ITEM	STATUS	COMMENT
Components	Standard	All components according to assembly plan
EEPROM (U2)	NOT PRESENT	
R916	NOT PRESENT	no PEX configuration by I2C
Firmware	Programmed	"generic7-D1111-A1110-L1101-C1100.mcs"
FW switch (SW5)	(1101) RTM_TCLKA PCIe source	for use with LEGACY boards and x16 RTM
J36/J37	ON	
IPMC	NOT PRESENT	
Mechanics	Not Assembled	LED kits assembled
PCIe test	OK	with ATCA-PTSW-AMC4 RTM v2.1 #2 , cable, OSSx4
LEDs	OK	
Current location	IST, Lisbon.

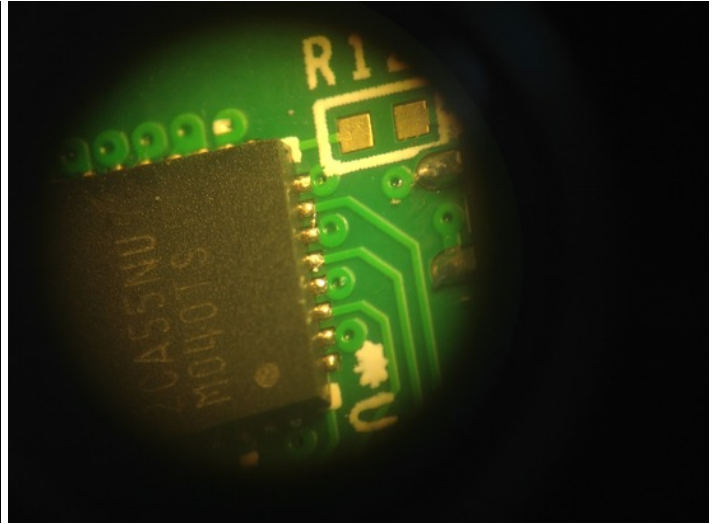
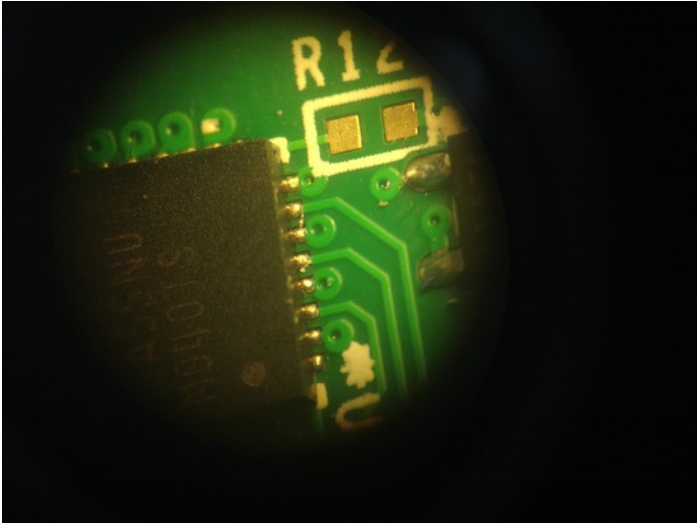
2. Faulty soldering on U100 was detected, as shown on pictures
